RE: MIP-16-04 at 2415 Dillow Street

TENTATIVE IMPROVEMENT PLAN
2415 Dillow Street Partition
T.2S., R.1E, Section 24, TL 7300-7400
City of West Linn, Oregon

2415 Dillow Street Partition Tentative Plan

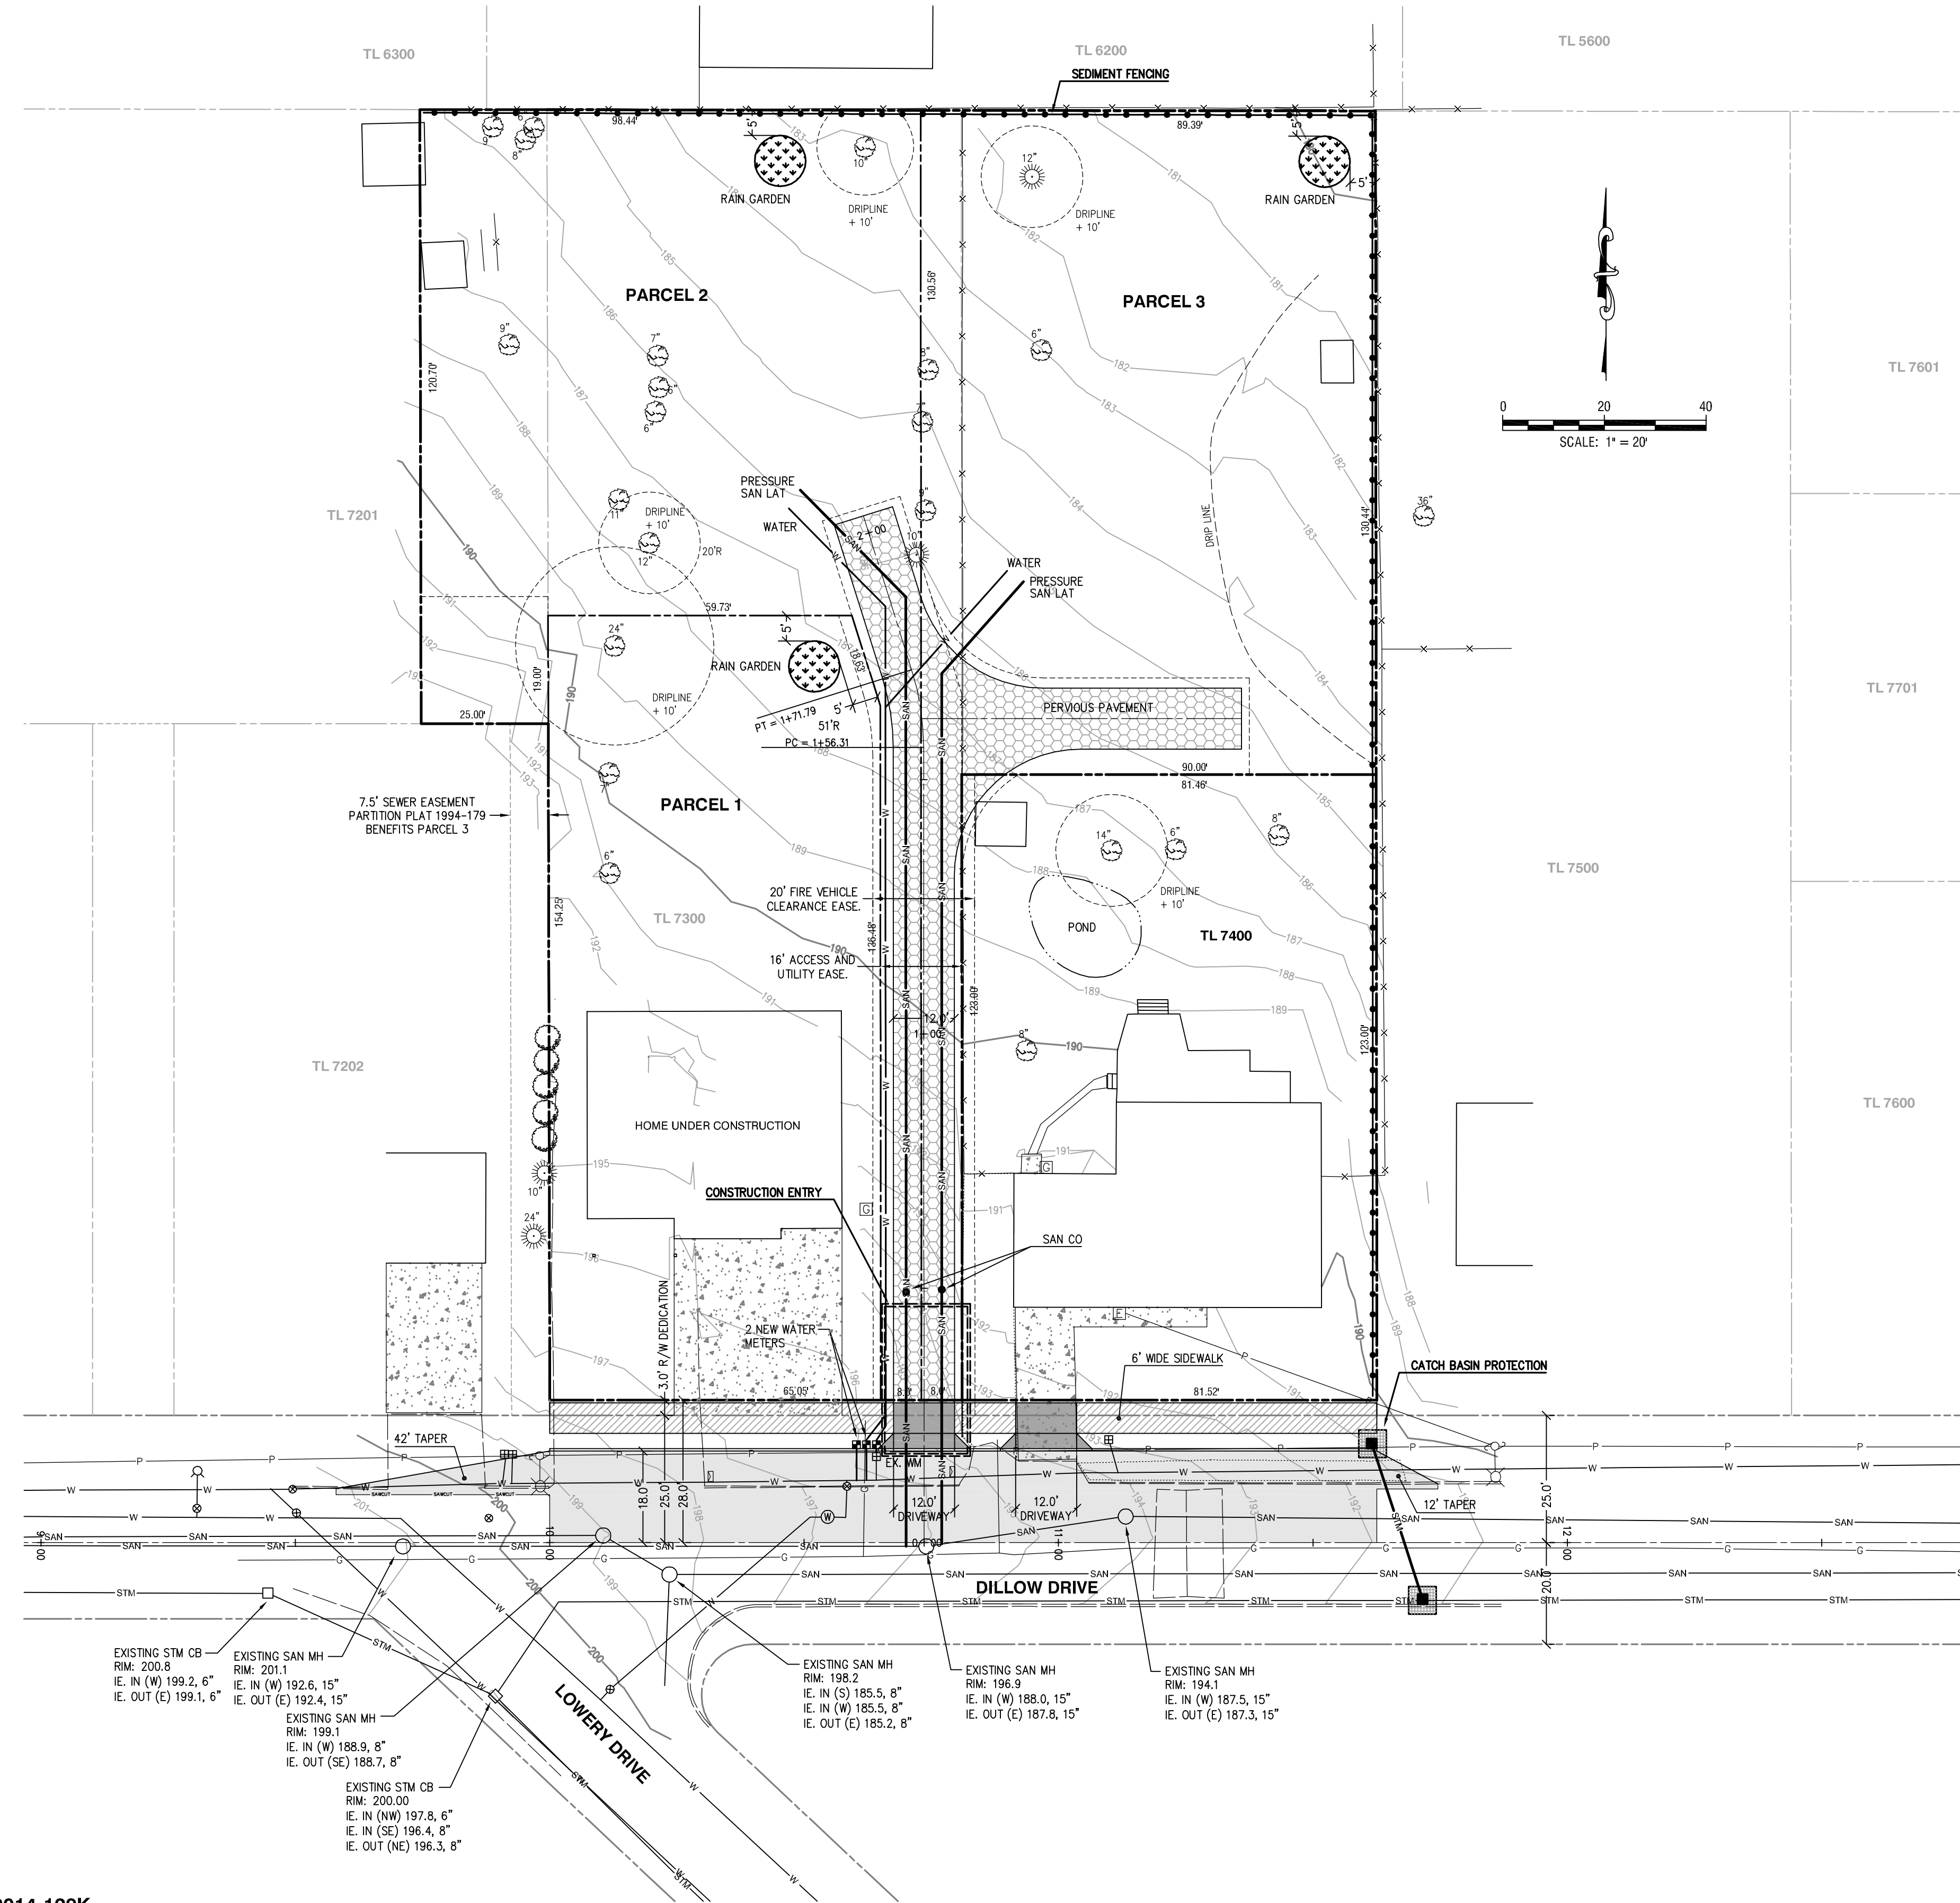
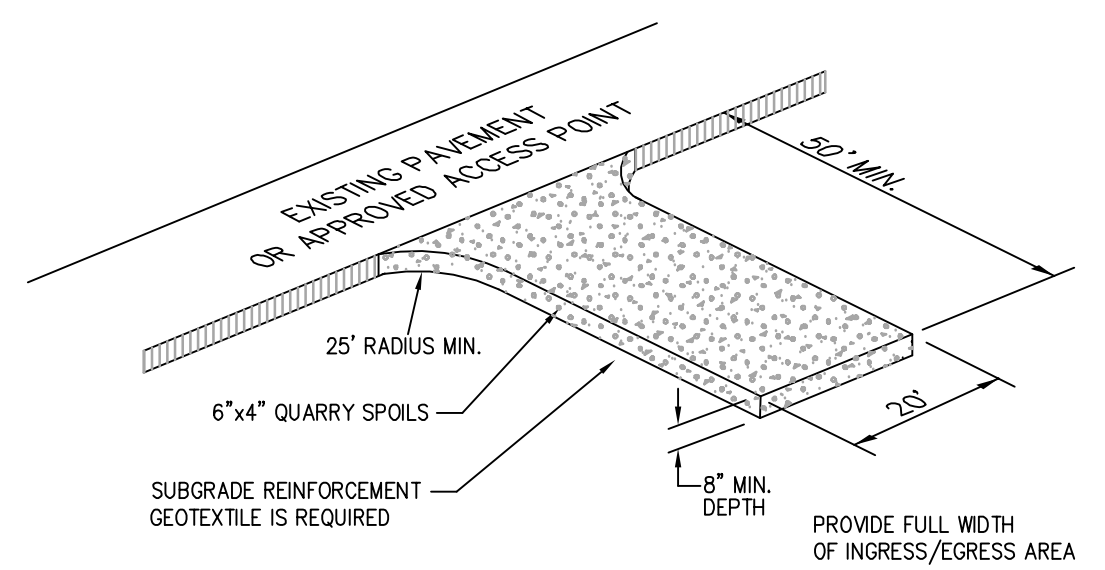
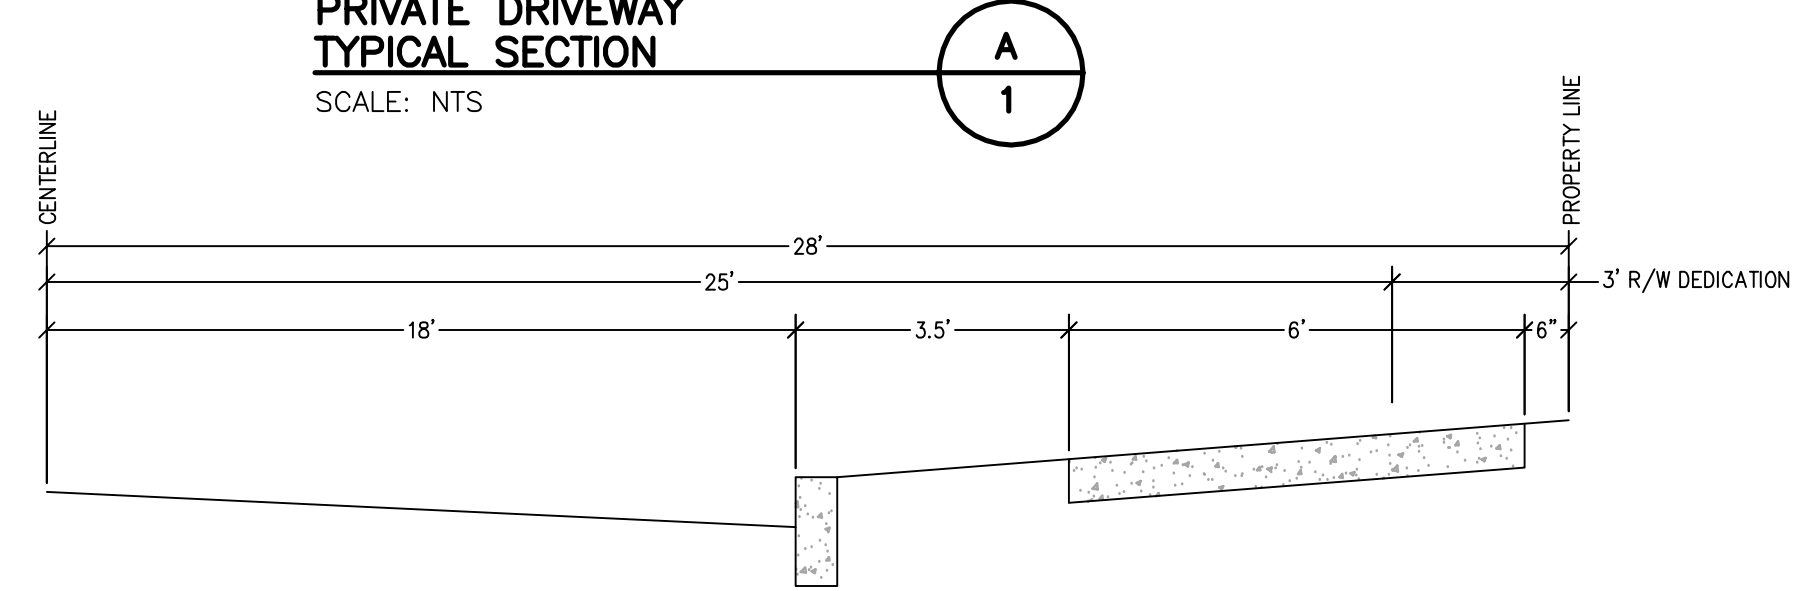
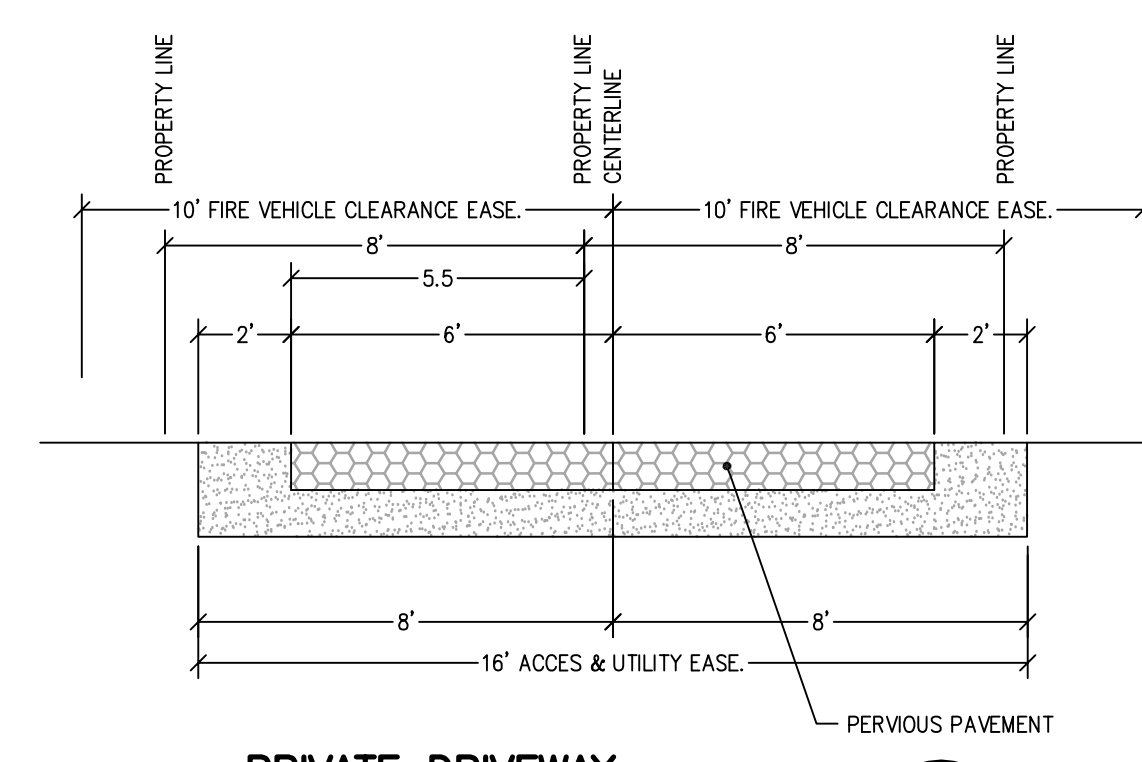
85.160(E) (1) The Tentative Plan has been modified to clearly identify the location and widths for the existing street and rights-of-way. The Preliminary Utility Plan shows proposed street improvements, new water services, sanitary sewer, and storm drainage and rain garden locations.

85.160 (E) (7) The Preliminary Utility Plan identifies the size and location of existing sewers, water mains, culverts, drain pipes, gas, electric, and other utility lines within the site, and in the adjoining streets and property.

85.160 (F) (2) The Preliminary Utility Plan shows the type, method, and location of any erosion prevention and sediment control measures and/or facilities in accordance with the most current version of Clackamas County's Erosion/Sedimentation Control Plans Technical Guidance Handbook.
